AGENDA
Design Review Committee
November 8, 2023 – REGULAR MEETING

Town of Jackson Design Guidelines Checklist

Item Number: P23-175

Response to Town of Jackson DRC Comments dated 2023 September 26

A2 GUARDRAIL @ RETAINING WALL
SCALE: 3/4" = 1'-0"

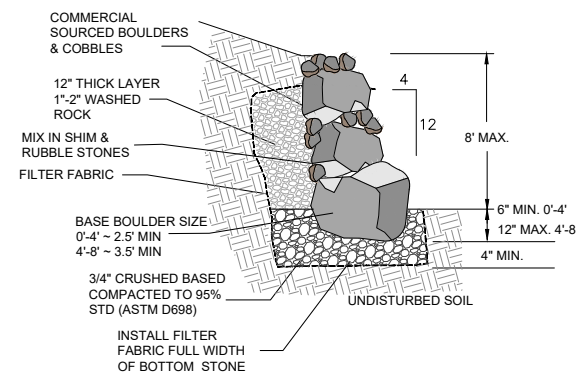
- Provide more details on the guardrails along the rear of the property. **See details A2 & C2 on sheet A501. Also, see the attached guardrail/ boulder wall exhibit.**

1 **C113** **TYPICAL BOULDER DRYSTACK
RETAINING WALL DETAIL**

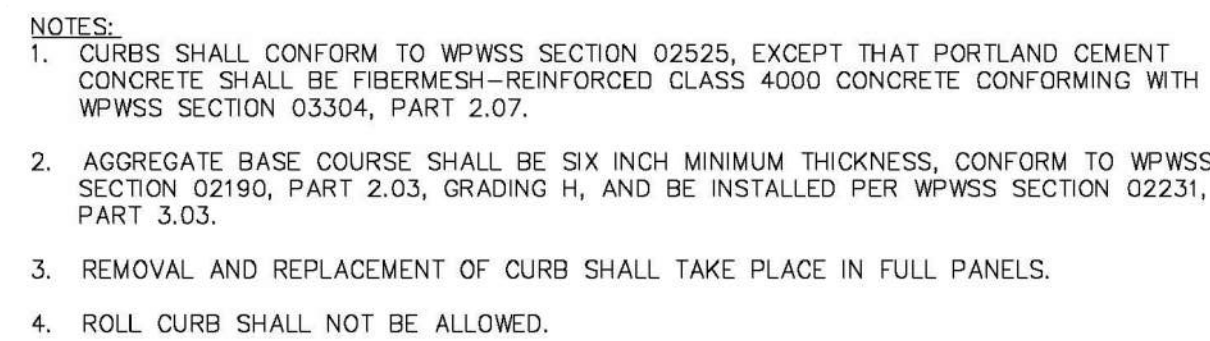
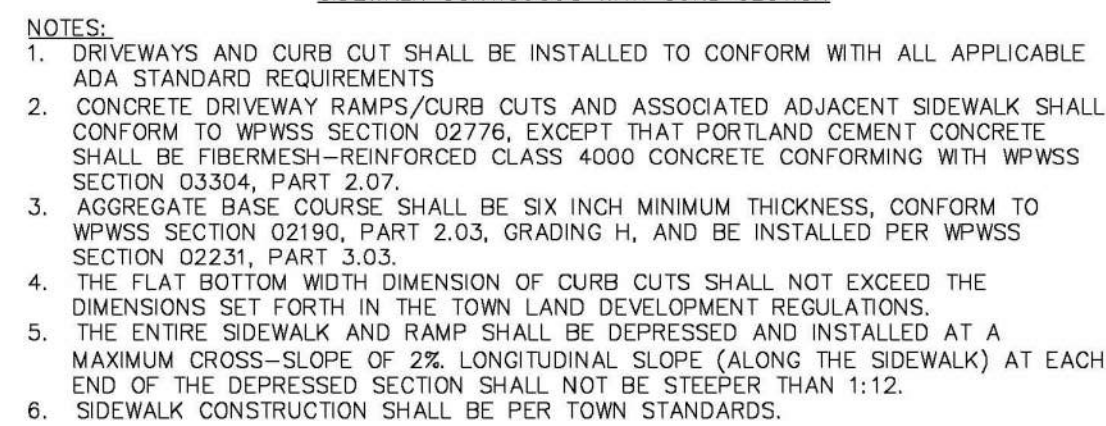
- d. Provide more details on the dry-stack boulder wall along the southern portions of the property.

- Provide more details on the dry-stack boulder wall along the southern portions of the property. **See boulder wall detail 1 on sheet C113 and detail A2 on A501. Also, see the attached guardrail/ boulder wall exhibit.**

A1 COURTYARD CURB PLANTER DETAIL
1" = 1'-0"

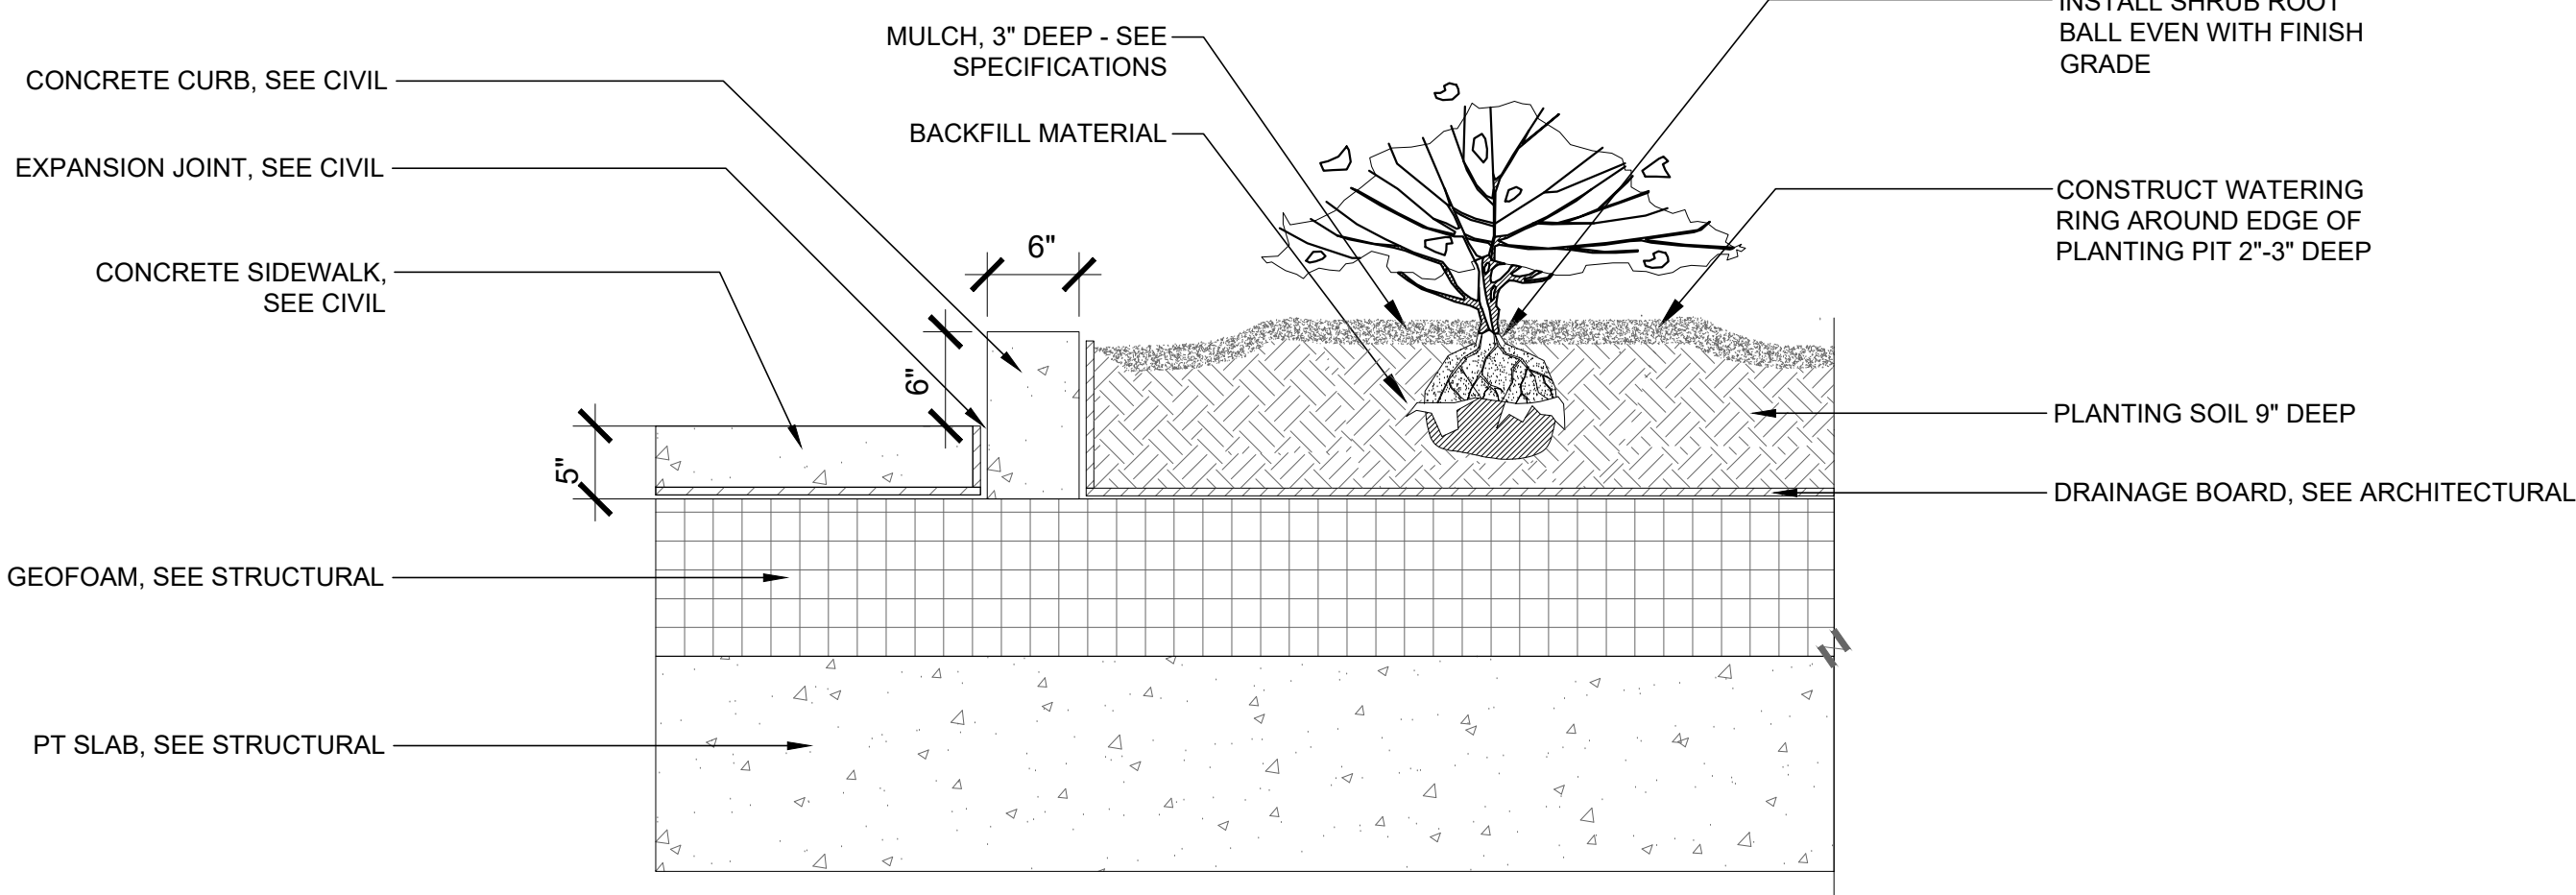
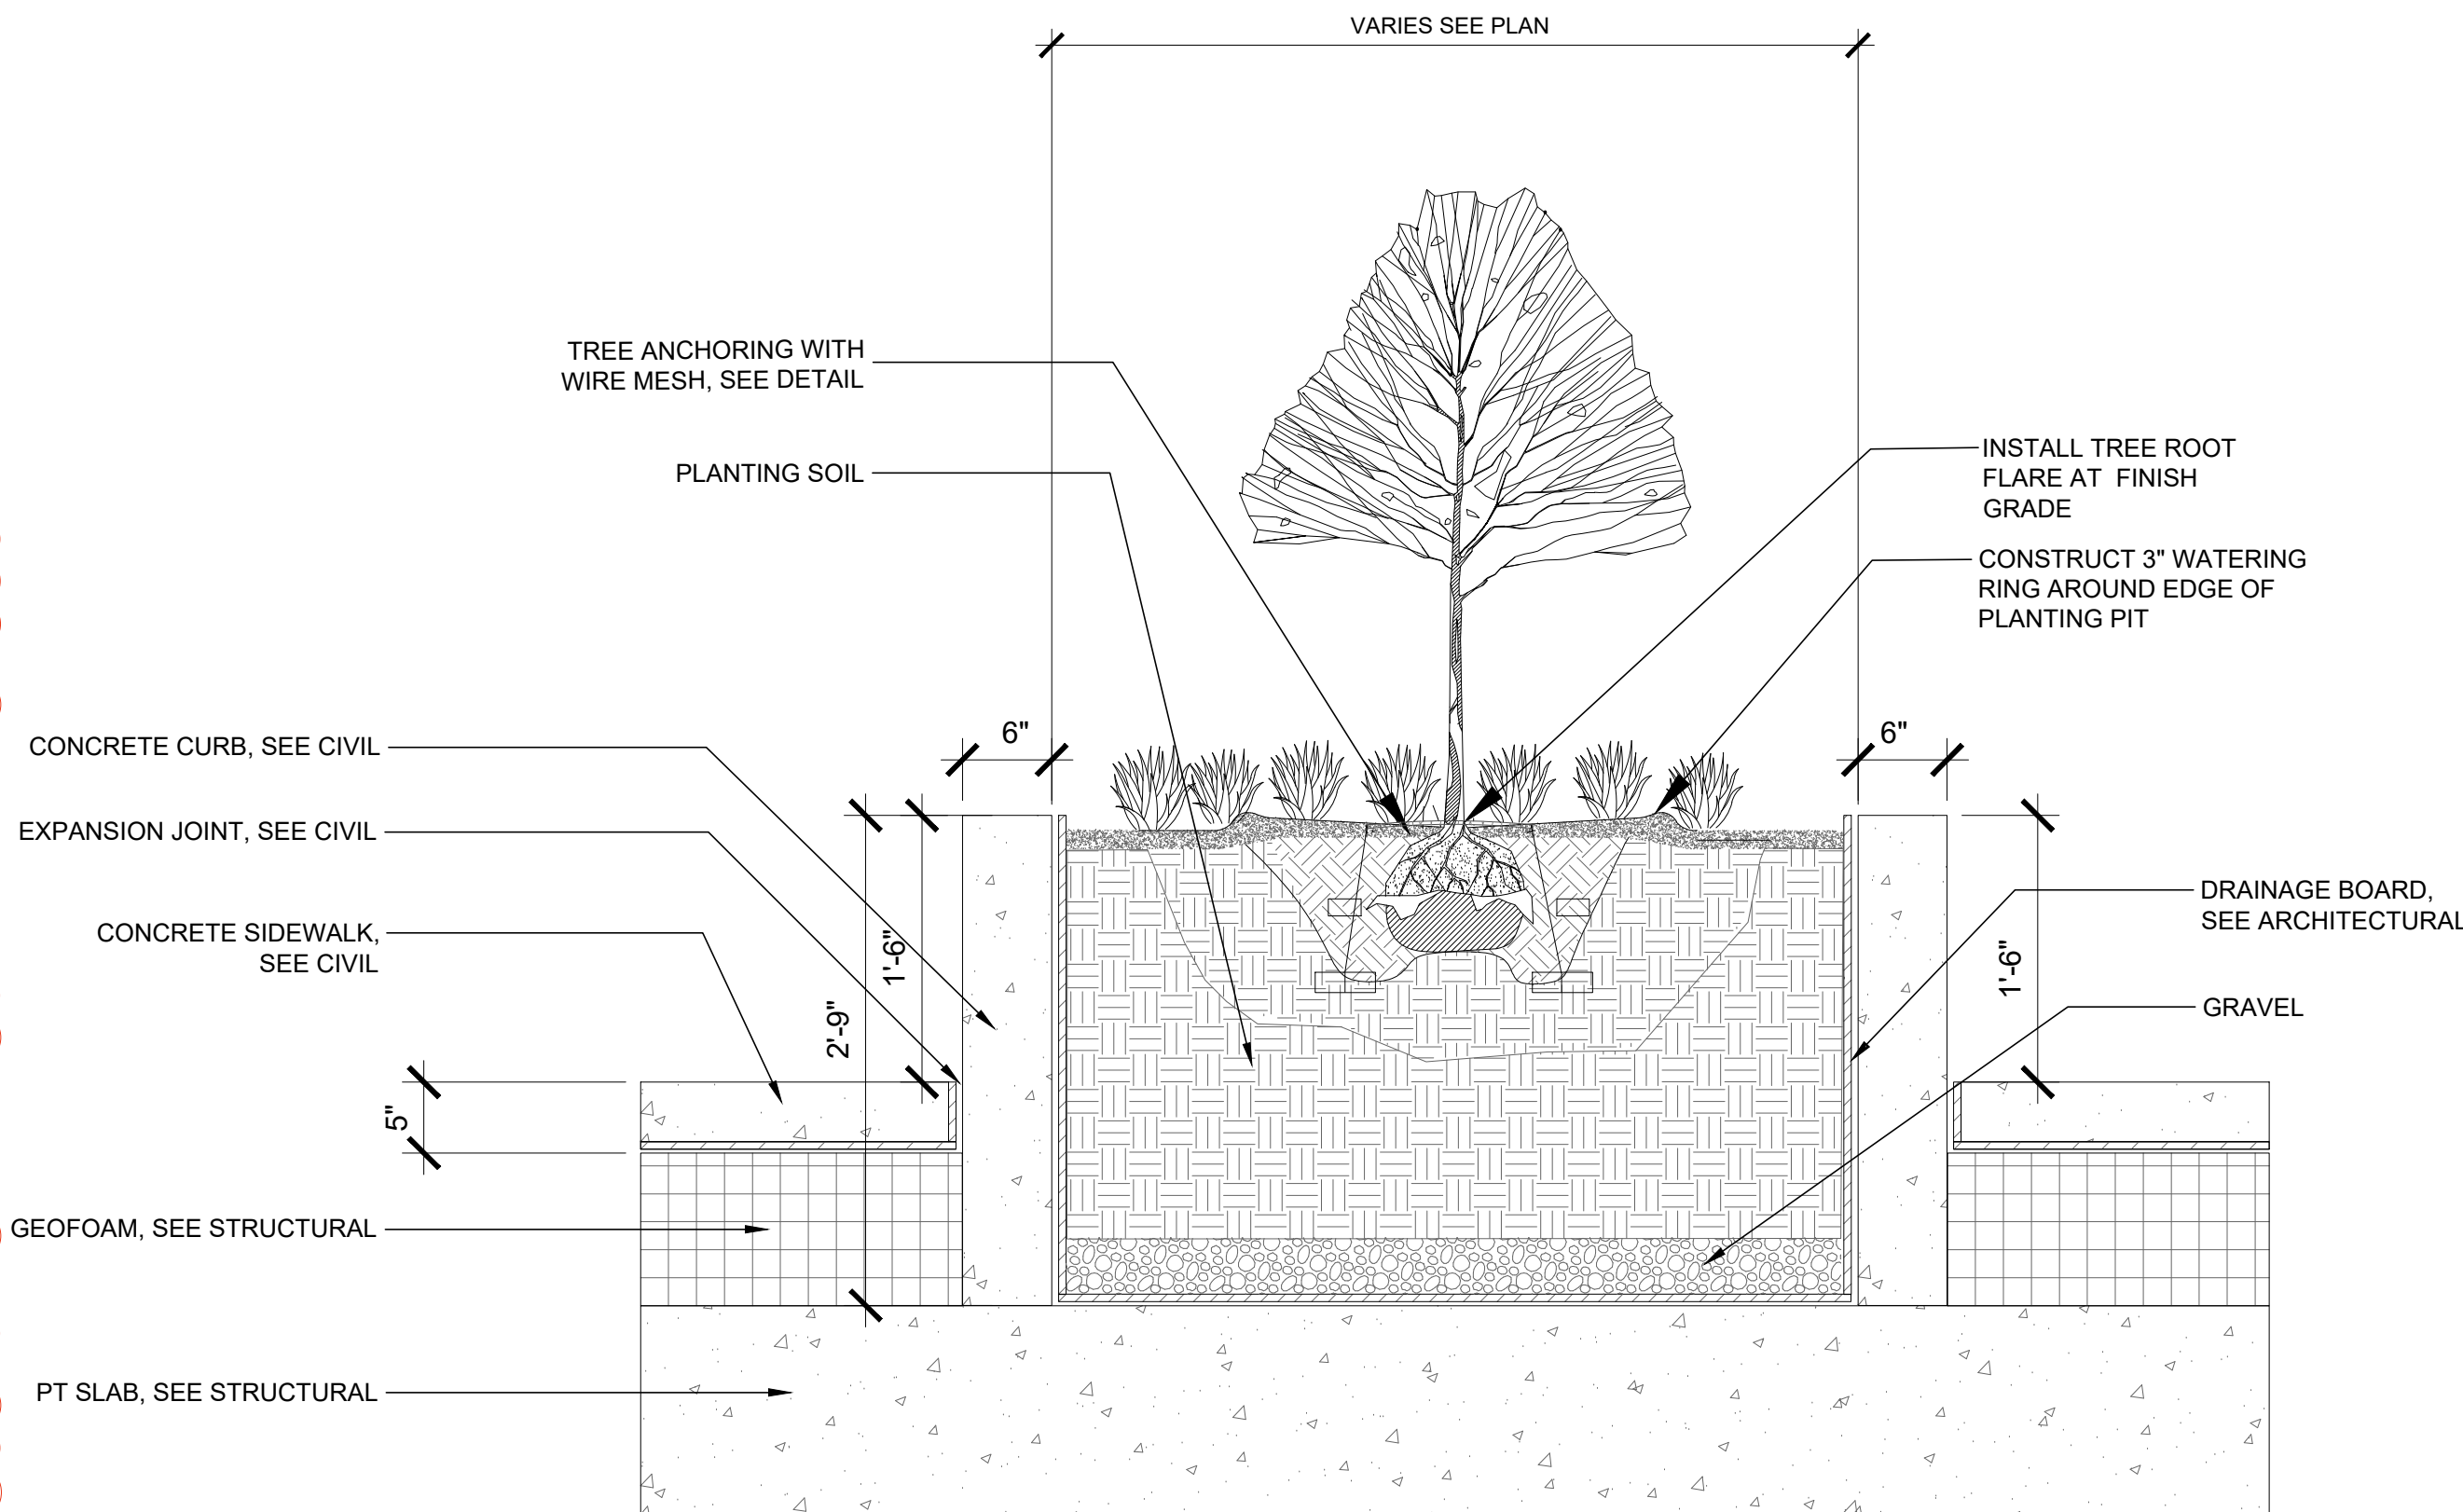
- b. Provide details on the courtyard landscaping, specifically on the landscaping and trees in planter beds.

Response: Details on the courtyard landscaping have been provided on sheet LA601.

- Provide details on the courtyard landscaping, specifically on the landscaping and trees in planter beds. **Those details have been provided on sheet LA601.**
